STAFF RECOMMENDATION
2115 Westwood Avenue
December 21, 2016

Application: New construction—outbuilding
District: Hillsboro-West End Neighborhood Conservation Zoning Overlay
Council District: 18
Map and Parcel Number: 10415040200
Applicant: Pam Stoll
Project Lead: Melissa Sajid, melissa.sajid@nashville.gov

Description of Project: The request is to construct an addition to an existing carport. **Recommendation Summary:** Staff recommends approval of the outbuilding with the condition that Staff approved the materials for the windows, doors, and roof color prior to purchase and installation. With this condition, staff finds that the outbuilding meets Section II.B.h. of the Hillsboro – West End Neighborhood Conservation zoning overlay design guidelines for this neighborhood. *The Commission does not have the authority to approve the use. This recommendation is for the design of the building based on the proposed use.*	**Attachments** **A:** Site Plan **B:** Elevations

Figure 2: Existing carport

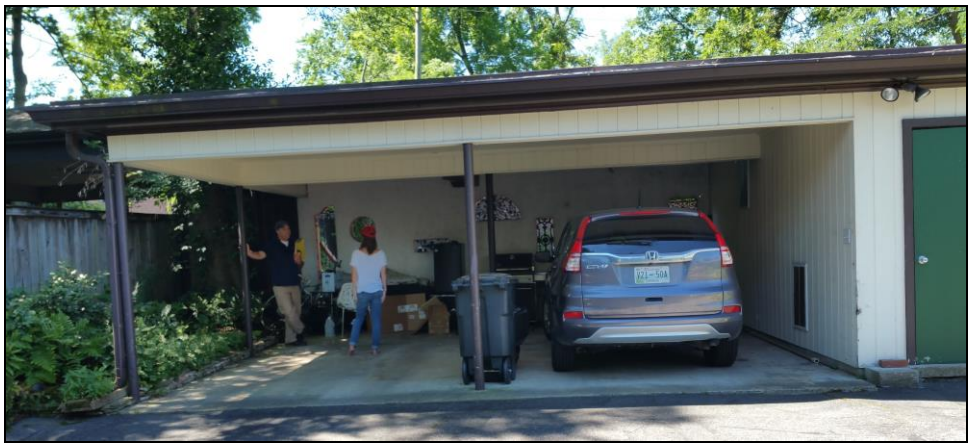
Analysis and Findings: Application is to enclose an existing carport (Figure 2) and add a half-story. The plan proposes to add approximately eighty square feet (80 sq. ft.) to the footprint on the front of the carport to accommodate the garage doors. The proposed outbuilding does not include a dwelling unit.

SITE PLAN

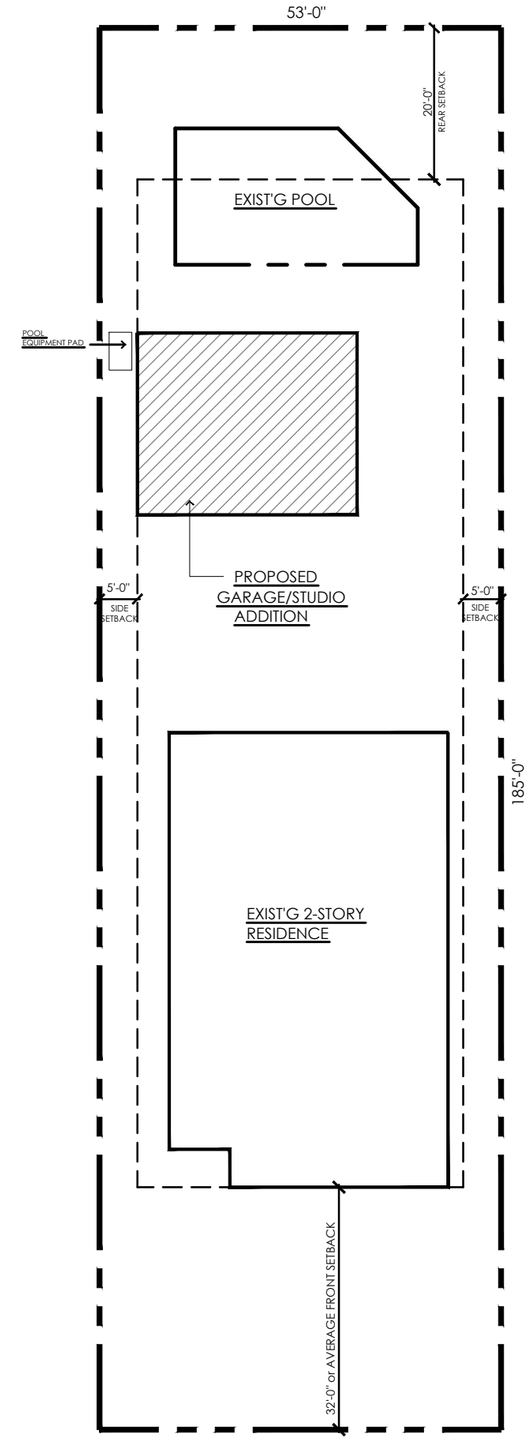
The outbuilding is situated behind the historic house in the same location as the existing carport and will be accessed from the existing driveway on Westwood Avenue. While the vehicular doors will be oriented to the street, the majority of the outbuilding is located behind the historic house and will not likely be visible from the street. As a result, staff finds the proposed single two-bay garage door appropriate in this case and-finds that the project meets Section II.B.h.1 of the design guidelines.

The outbuilding meets all setbacks required by zoning and maintains a separation of at least twenty feet (20') between the house and the DADU. The outbuilding will continue to be accessed via the existing curb cut and driveway that serves the carport. Staff finds that the project meets Section II.B.h.2 of the design guidelines.

FRONT ELEVATION - NORTH

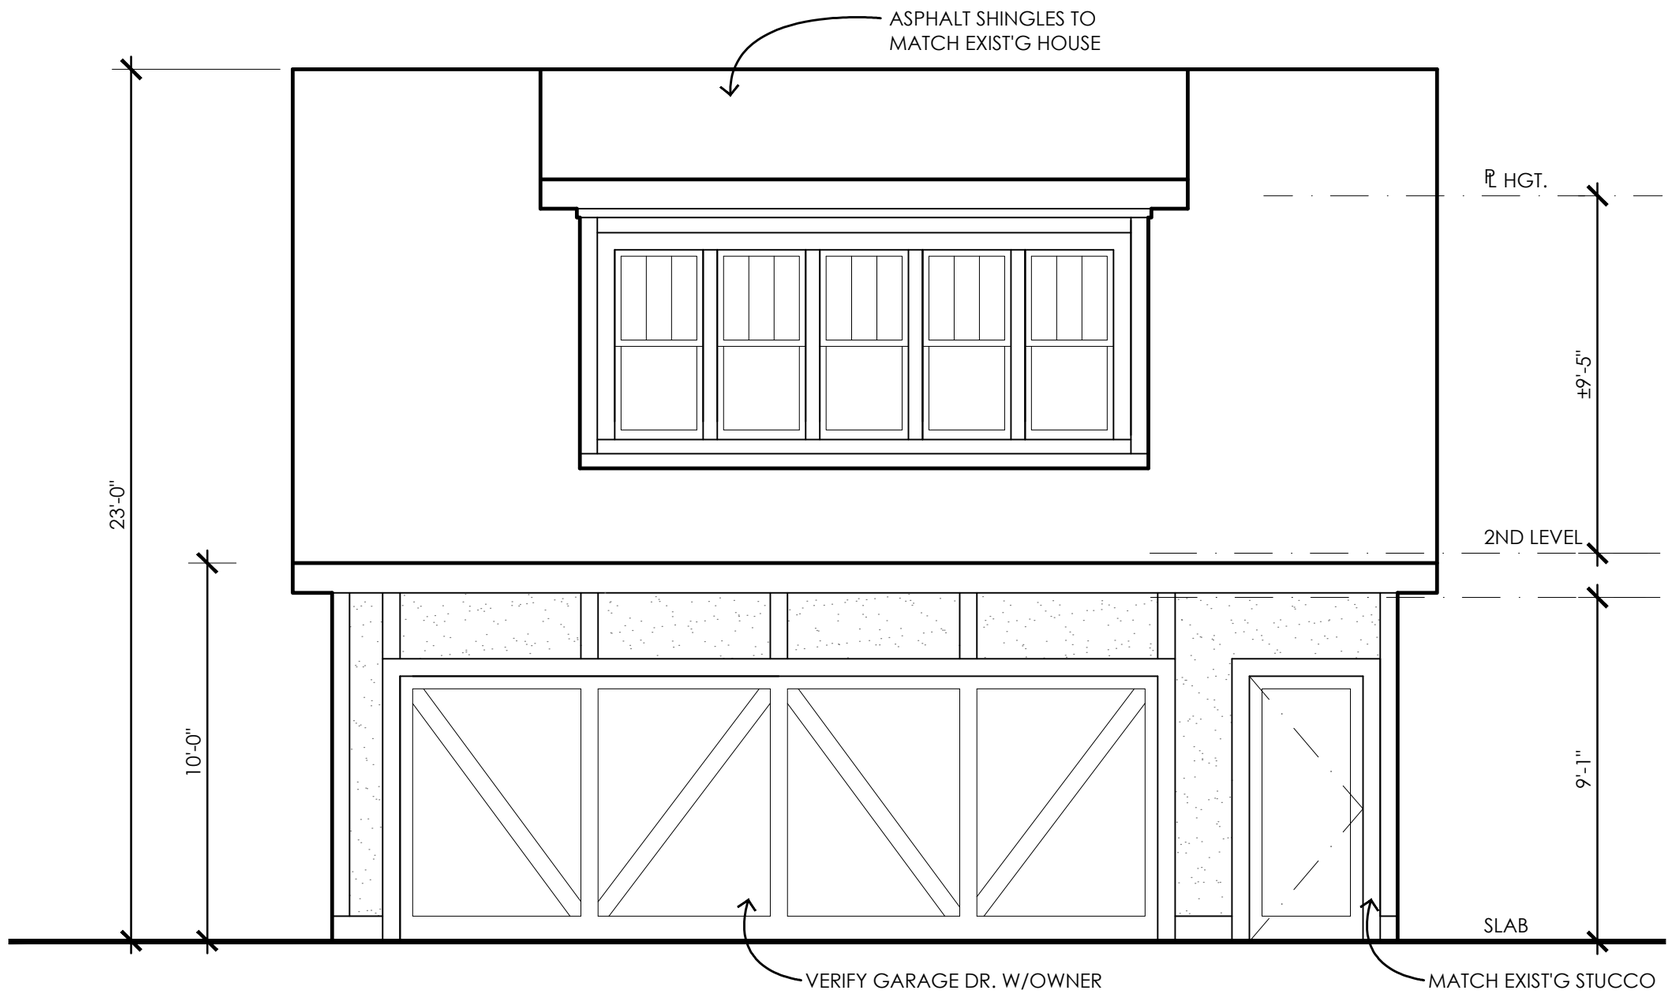
The proposed outbuilding addition is one and one-half story and does not exceed the maximum ridge height, average eave height, and footprint per the design guidelines. The plan includes dormers on the front and rear of the outbuilding. Both dormers sit back from the wall below by two feet (2') as required by the design guidelines. The front dormer does not exceed more than fifty percent (50%) of the roof plan as required; however, the proposed rear dormer does exceed fifty percent (50%). Since the rear dormer will not be visible from the street and the proposed outbuilding does not include a dwelling unit, staff recommends approval of the proposed rear dormer.
